ADDENDUM #1

TO: ALL PLAN HOLDERS AND POTENTIAL BIDDERS
FROM: TIFFANY McCANTS, PURCHASING OFFICER
SUBJECT: OAKLEY ELEMENTARY SCHOOL EXIT RAMP AND AREA OF REFUGE

(RFP# 11-20)

Pre-Bid Meeting Minutes/Addendum #1

FIRST FLOOR PLAN

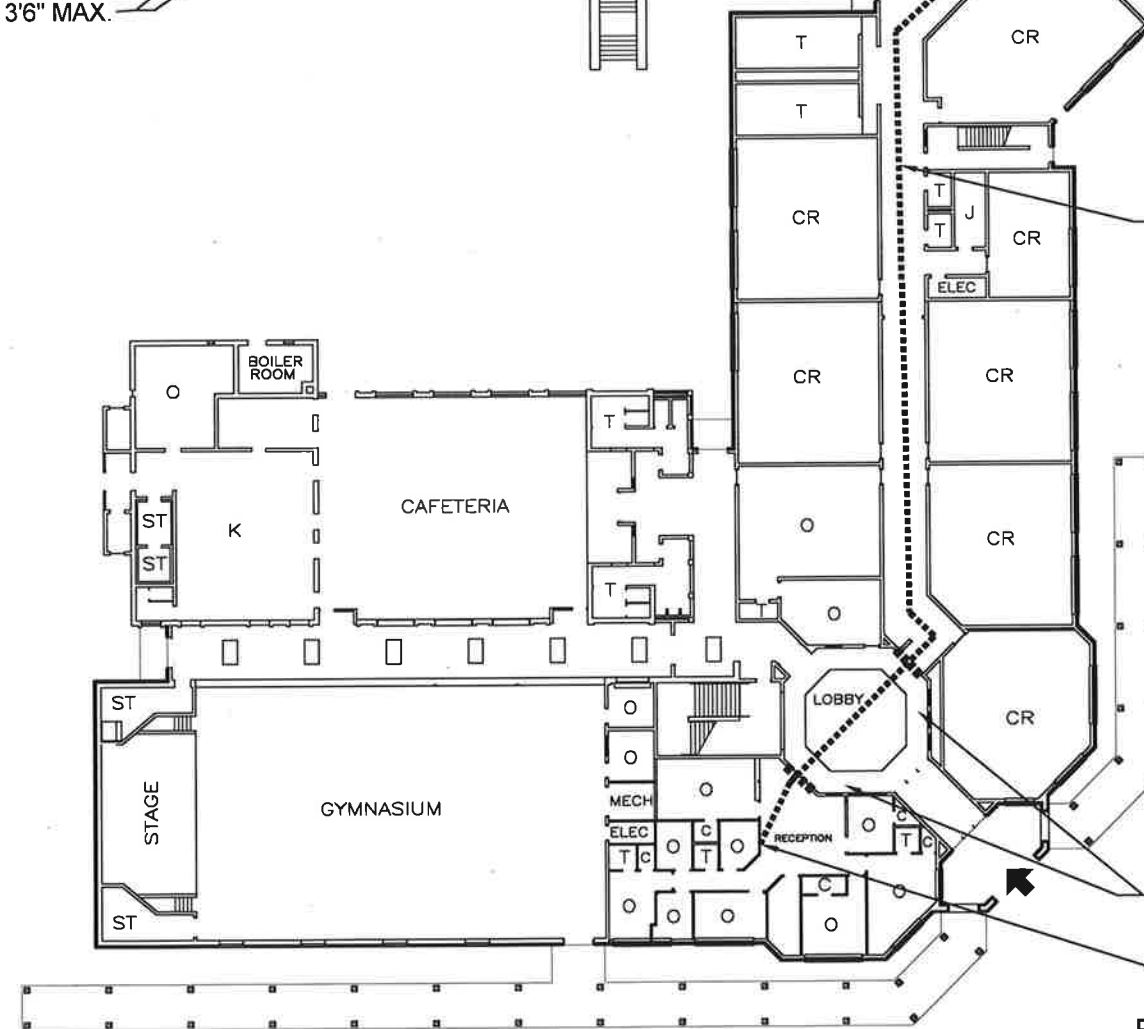
AREA OF RESCUE ABOVE: VERTICAL DROP IN VESTIBULE OR MAY BE SURFACE MOUNT IN CORNER. REMAINDER OF HORIZONTAL RUN SHALL BE ABOVE CEILING AND INDEPENDENTLY SUPPORTED UTILIZING "J" HOOKS SPACED 3'6" MAX.

ELECT. PANEL WITH AVAILABLE SPACE FOR CONTRACTOR TO UTILIZE FOR AREA OF RESCUE AND OTHER LIFE SAFETY COMPONENTS. NOTE: CORRIDOR WALLS ARE RATED AND MUST BE FIRE STOPPED AT PENETRATIONS. CONCEAL CABLING ABOVE CEILINGS WHEREVER FEASIBLE.

CROSS CORRIDOR HATCHES INDICATE RATED PARTITIONS REQUIRING FIRE STOPPED PENETRATIONS

NOTE: DASHED INDICATES PATH OF LOW VOLT COMM FROM AREA OF RESCUE TO OFFICE PANEL.

NOTE: HARD CEILING PERIMETER AT LOBBY. OTHER AREA HAVE LAY-IN CEILINGS. AREA OF RESCUE PANEL SHALL BE LOCATED IN OFFICE TO LEFT OF FIRE PANEL.

SECOND FLOOR PLAN

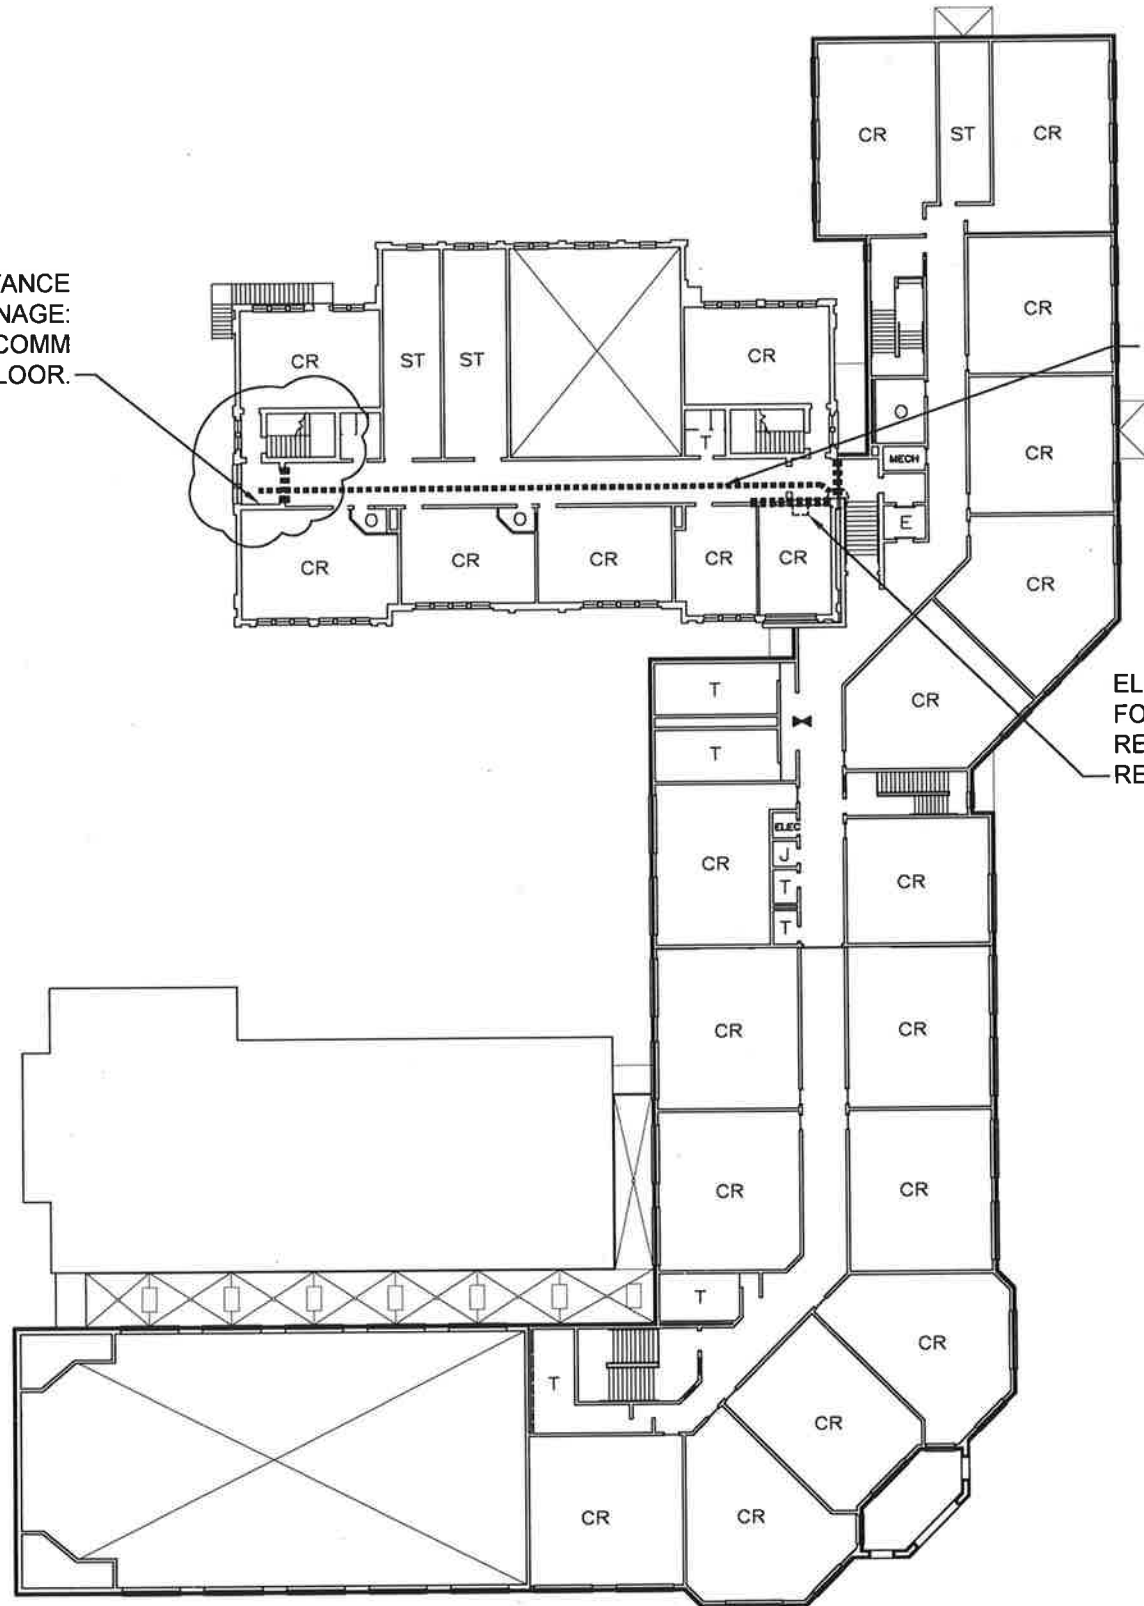
AREA OF RESCUE ASSISTANCE CONTROLS AND SIGNAGE: SEE PATHWAY FOR COMM CABLING ON 1ST FLOOR.

ALTERNATIVE ROUTE FOR COMM CABLING TO OFFICE. NOTE RATED WALLS AT STAIRS

ELECTRICAL PANEL WITH AVAILABLE SPACE FOR CONTRACTOR POWER TO AREA OF RESCUE. CORRIDOR WALLS ARE RATED AND REQUIRE FIRESTOP PENETRATIONS.
